Access Compliance Report

Public Rights-of-Way

Intersection ID: 30171	Main Street: BIESTERFIELD_DR	Cross Street: CLIFFROSE_WY	Location: E
ADA ID: 111DA8A190FD	Ramp Type: BlendTrans1	Initial Pass/Fail: Pass	Overall Compliance: No
Severity Score: 5			
Codes/Mitigation Info/Possible Solution		Field Measurements/Component Compliance

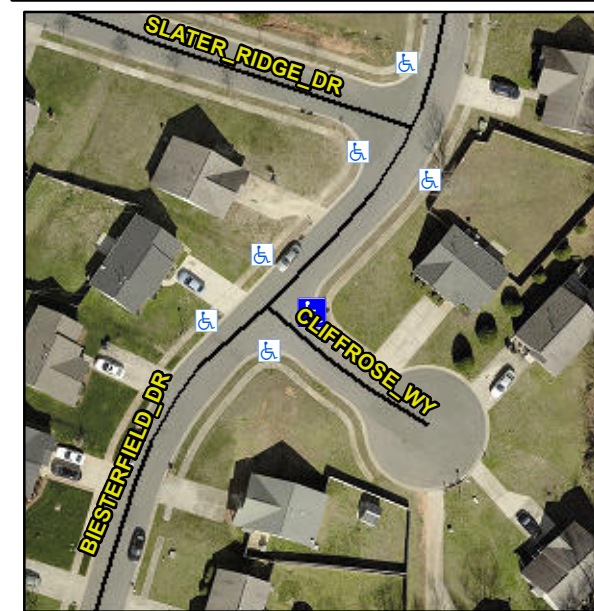
Not Found, R304.2.1, R304.2.2-Perp, R304.3.2-Para, R305.2, R304.5.4

Remove & Replace Curb Ramp With Two New Directional Ramps or Equivalent. Remove & Replace Gutter.
